V2500-A5 SERIES PROPULSION SYSTEMS SERVICE BULLETIN

This document transmits the Revision 3 of Service Bulletin V2500-ENG-73-0219.

V2500-ENG-73-0219

**ENGINE – VARIABLE STATOR VANE (VSV) ACTUATOR – LOW PRESSURE (LP) RETURN LINE RE-ROUTE
PIPEWORK****1. Planning Information****A. Effectivity****(1) Airbus A319**

CLIP POSITION 5770

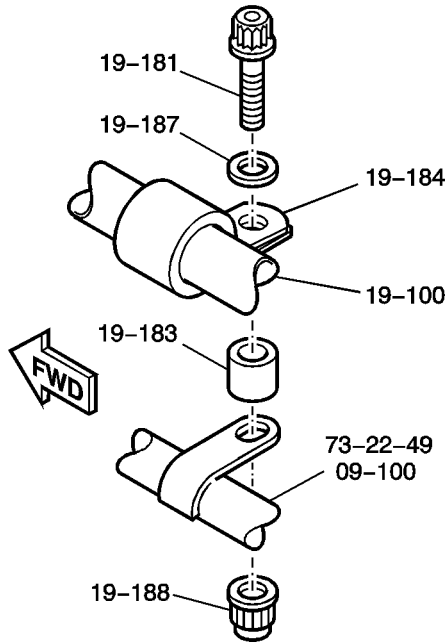
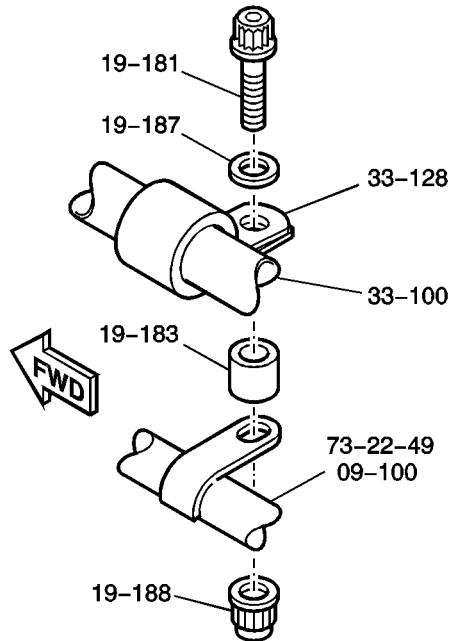
- (i) Remove the nut (73-11-49, 19-188), the washer (73-11-49, 19-187), the spacer (73-11-49, 19-183) and the old bolt (73-11-49, 19-181), P/N 4W0106, that attach the old clip (73-11-49, 19-184), P/N 400WSS6 to the lug on tube (73-22-49, 09-100).

- (c) At the changed clip position CP5770:
 - (i) Loosely install the new bolt (73-11-49, 19-181), P/N 4W0107, the washer (73-11-49, 19-187), the spacer (73-11-49, 19-183) and the nut (73-11-49, 19-188) that attach the new clip (73-11-49, 33-128), P/N 400WSS6 to the lug on tube (73-22-49, 09-100).

(i) At the clip position CP5770 torque the nut (73-11-49, 19-188) to 36-45 lbf in. (4-5 Nm).

CLIP POSITION 5766

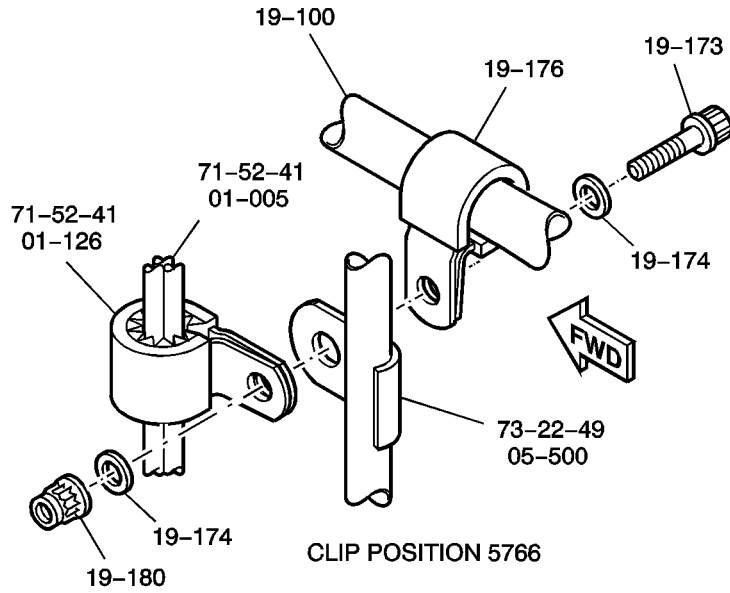
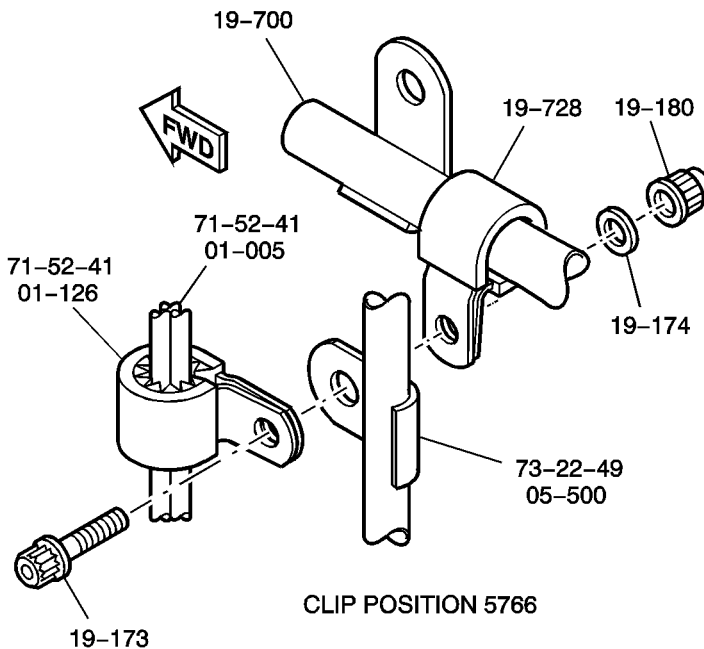
- (e) At the clip position CP5766:
 - (i) Remove the nut (73-11-49, 19-180), the two washers (73-11-49, 19-174) and the old bolt (73-11-49, 19-173), P/N 4W0103 that attach the old clip (73-11-49, 19-176), P/N AS62406 and the clip (71-52-41, 01-126) to the lug on tube (73-22-49, 05-500).

- (g) At the changed clip position CP5766:
 - (i) Loosely install the new bolt (73-11-49, 19-173), P/N 4W0105, the washer (73-11-49, 19-174) and the nut (73-11-49, 19-180) that attach the clip (71-52-41, 01-126) and the new clip (73-11-49, 19-728), P/N AS62406 to the lug on tube (73-22-49, 05-500).

(v) At the clip position CP5766 torque the nut (73-11-49, 19-180) to 36-45 lbf in. (4-5 Nm).

CLIP POSITION 1460

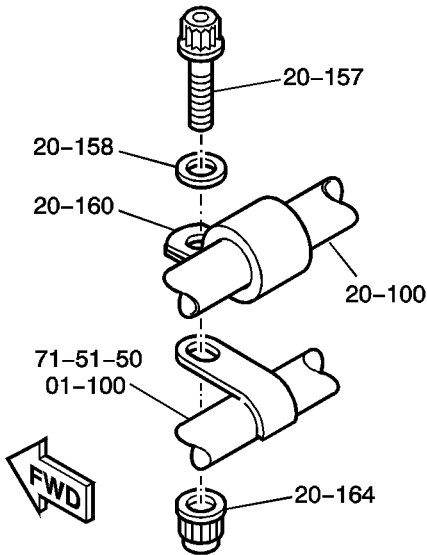
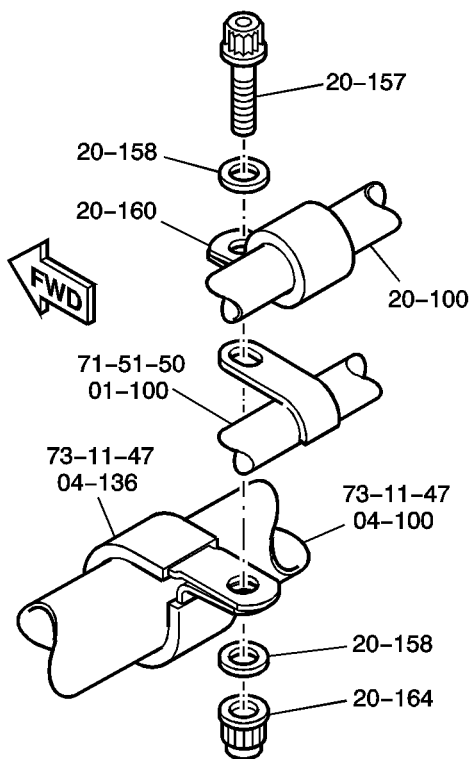
(d) At the changed clip position CP1460:

(i) Remove the nut (73-11-49, 20-164), the old bolt (73-11-49, 20-157), P/N 4W0102 and the washer (73-11-49, 20-158) that attach the clip (73-11-49, 20-160) to the lug on tube (71-51-50, 01-100).

(ii) Loosely install the new bolt (73-11-49, 20-157), P/N 4W0104, the two new washers (73-11-49, 20-158), P/N K8831 and the nut (73-11-49, 20-164) that attach the clip (73-11-49, 20-160) and the clip (73-11-47, 04-136) to the lug on tube (71-51-50, 01-100).

- (h) Safety the tube nuts on tube (73-11-47, 04-100) with CoMat 02-126 Lockwire.
- (i) Torque the four nuts (73-11-49, 10-732), (73-11-49, 20-164), (73-11-49, 10-172) and (71-51-41, 02-906) of the clip positions CP1489, CP1460, CP1461 and CP1465 to 36-45 lbf in. (4-5 Nm).

CLIP POSITION 1461

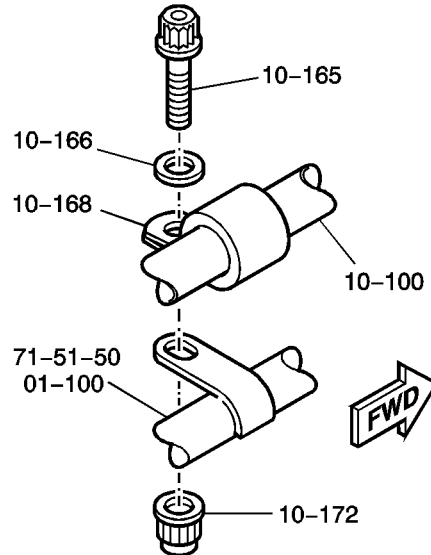
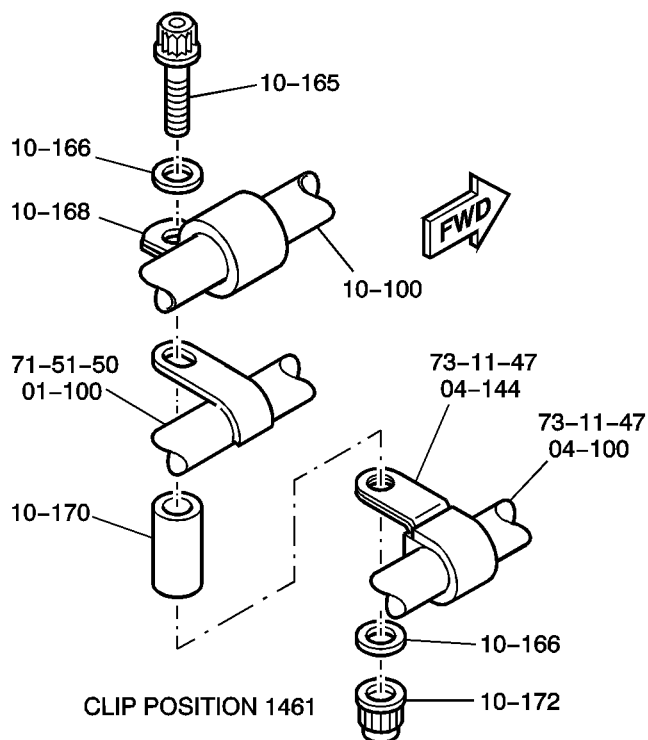
(e) At the changed clip position CP1461:

(i) Remove the nut (73-11-49, 10-172), the washer (73-11-49, 10-166) and the old bolt (73-11-49, 10-165), P/N 4W0102 that attach the clip (73-11-49, 10-168) to the lug on tube (71-51-50, 01-100)

- (ii) Loosely install the new bolt (73-11-49, 10-165), P/N 4W0114, the two new washers (73-11-49, 10-166), P/N K8831, the new spacer (73-11-49, 10-170), P/N UP10480 and the nut (73-11-49, 10-172) that attach the clip (73-11-49, 10-168) and the new clip (73-11-47, 04-144), P/N AS62406 to the lug on tube (71-51-50, 01-100).
- (f) At the changed clip position CP1465:
 - (i) For Pre SBE 71-0288 engines:

CLIP POSITION 0921

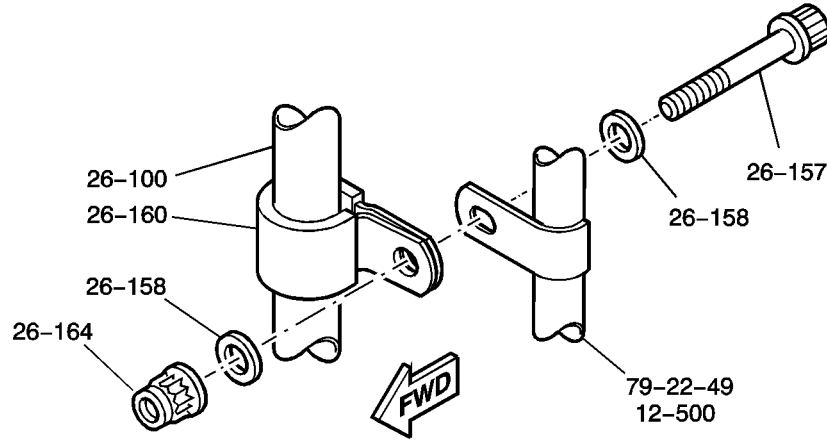
Remove	Incorporate	Reason for change
All Pages of the Service Bulletin.	Pages 1 to 42 of the Service Bulletin.	Change clip positions CP0921 and CP6159. To update the Illustrations. To update the Accomplishment Instruction. To update the Material Information.
All Pages of the Supplement.	Page 1 of the Supplement.	To change the Mod Kit numbers. To update the prices.

Description	MKVA573021902	MKVA573021904
To be replaced (Bolt of CP6159)	4W0104	4W0111
To be added (Spacer of CP6159)	N/A	UP10479
To be replaced (Bolt of CP0921)	4W0104	4W0118
To be added (Spacer of CP6159)	N/A	UP10481

- R (ii) Loosely install the new bolt (73-11-49, 26-157), P/N 4W0118,
R the two new washers (73-11-49, 26-158), P/N K8831, the new
spacer (73-11-49, 26-162), P/N UP10481 and the nut (73-11-49,
26-164) that attach the clip (73-11-49, 26-160) and the new
clip (73-11-47, 04-544), P/N AS62406 to the lug on tube
(79-22-49, 12-500).

- R (h) Torque the three nuts (73-11-49, 26-796), (73-11-49, 26-164) and (71-51-41, 01-877) of the clip positions CP1492, CP0921 and CP0789 to 36-45 lbf in. (4-5 Nm).

CLIP POSITION 1072

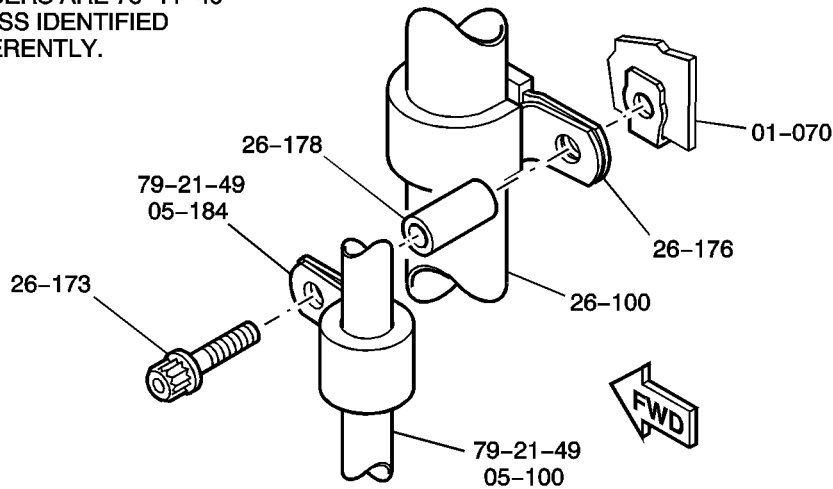
- (e) At the changed clip position CP1072:
- (i) Remove the old bolt (73-11-49, 26-173), P/N 4W0116 and the
spacer (73-11-49, 26-178) that attach the clip (79-21-49,
05-184) and the old clip (73-11-49, 26-176), P/N 400WSS16 to
the bracket (73-11-49, 01-070).

- (ii) Loosely install the new bolt (73-11-49, 26-173), P/N 4W0124, the new spacer (73-11-49, 26-179), P/N UP10479 and the spacer (73-11-49, 26-178) that attach the new clip (73-11-47, 04-560), P/N AS62406, the clip (79-21-49, 05-184) and the new clip (73-11-49, 26-176), P/N AS62416 to the bracket (73-11-49, 01-070).

- R (i) Torque the bolt (73-11-49, 26-173) of the clip position CP1072 to 36-45 lbf in. (4-5 Nm).
- R (j) Retighten and torque all adjacent hardware that have been loosened before, to ensure stress-free installation of tube (73-11-47, 04-500).

CLIP POSITION 6158

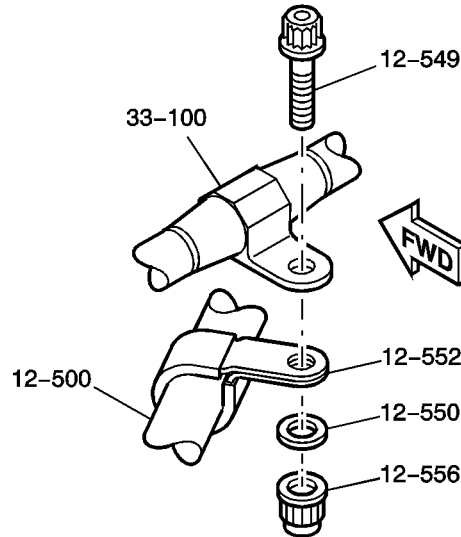
- (d) At the new clip position CP6158:
 - (i) Loosely install the new bolt (73-11-49, 12-549), P/N 4W0103, the new washer (73-11-49, 12-550), P/N K8831 and new nut (73-11-49, 12-556), P/N 4W0001 that attach the new clip (73-11-49, 12-552), P/N AS62406 to the lug on tube (73-11-49, 33-100).

(iv) At the clip position CP6158 torque the nut (73-11-49, 12-556) to 36-45 lbf in. (4-5 Nm).

CLIP POSITION 6159

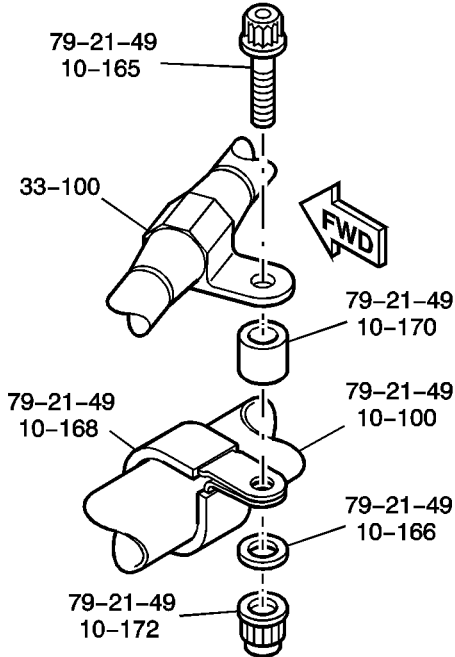
- (e) At the new clip position CP6159:
 - (i) Loosely install the new bolt (79-21-49, 10-165), P/N 4W0111, the new spacer (79-21-49, 10-170), P/N UP10479, the new washer (79-21-49, 10-166), P/N K8831 and new nut (79-21-49, 10-172), P/N 4W0001 that attach the new clip (79-21-49, 10-168), P/N AS62412 to the lug on tube (73-11-49, 33-100).

(ii) At the clip position CP6159 torque the nut (79-21-49, 10-172) to 36-45 lbf in. (4-5 Nm).

CLIP POSITION 6157

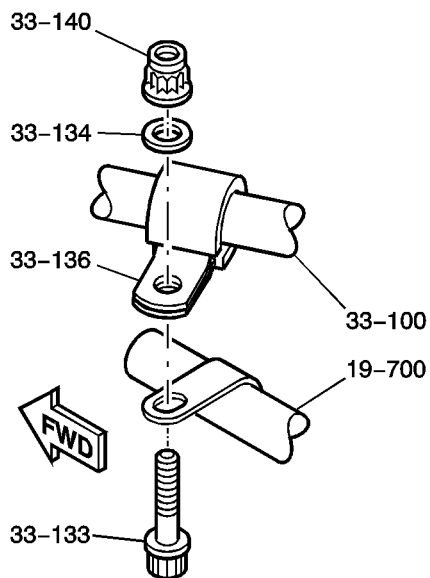
(h) At the new clip position CP6157:

(i) Loosely install the new bolt (73-11-49, 33-133), P/N 4W0103, the new washer (73-11-49, 33-134), P/N K8831 and the new nut (73-11-49, 33-140), P/N 4W0001 that attach the new clip (73-11-49, 33-136), P/N AS62406 to the lug on tube (73-11-49, 19-700).

(iii) At the clip position CP6157 torque the nut (73-11-49, 33-140) to 36-45 lbf in. (4-5 Nm).

CLIP POSITION 1489

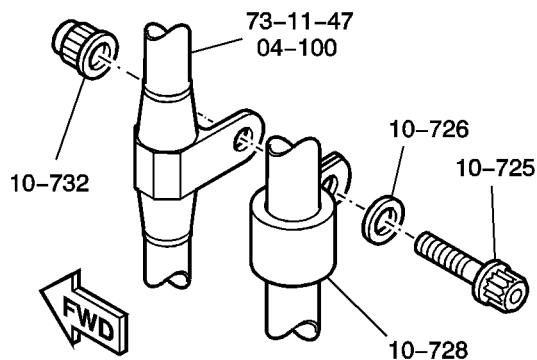
(c) At the new clip position CP1489:

(i) Loosely install the new bolt (73-11-49, 10-725), P/N 4W0104, the new washer (73-11-49, 10-726), P/N K8831 and the new nut (73-11-49, 10-732), P/N 4W0001 that attach the new clip (73-11-49, 10-728), P/N AS62408 to the lug on tube (73-11-47, 04-100).
